CITY OF TORRINGTON

To: Planning & Zoning Commission
From: Martin J. Connor, AICP, City Planner
Date: July 14, 2021
RE: Special Exception 21-09 & Site Plan #1378, Alam Realty Inc., add gasoline dispensers, canopy, storm drainage, parking, & modifications to building facade

BITUMINOUS CONCRETE LIP CURB

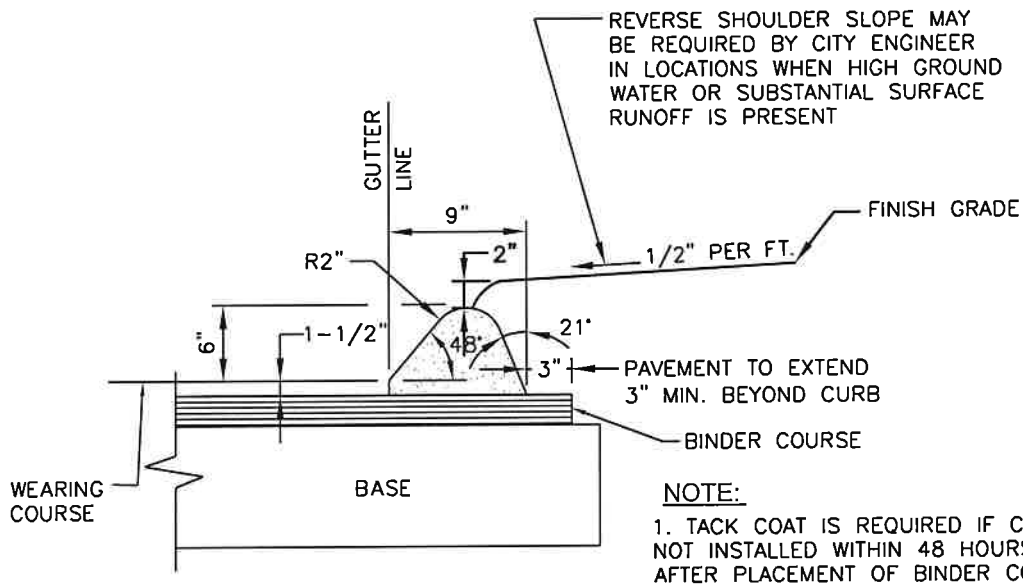
1. City detail for bit curb (attached) has the curb on the base course and top course butting up against the face of curb (7.5" mold) - The City does not want to have a new sawcut joint and a bituminous concrete patch strip in the road at the face of curb. Provide a detail for installing new bituminous curb along the existing edge of Circle Drive.
2. Sheet C5 vehicle turning:
 - a. Cars from gas pumps (or anywhere from the site) cannot exit onto Circle Drive or RTE 4 on the opposite side of the entrance.
 - b. Show WB-40 stopped at the Circle Drive stop bar such that trailer is not blocking opposite side of the road.
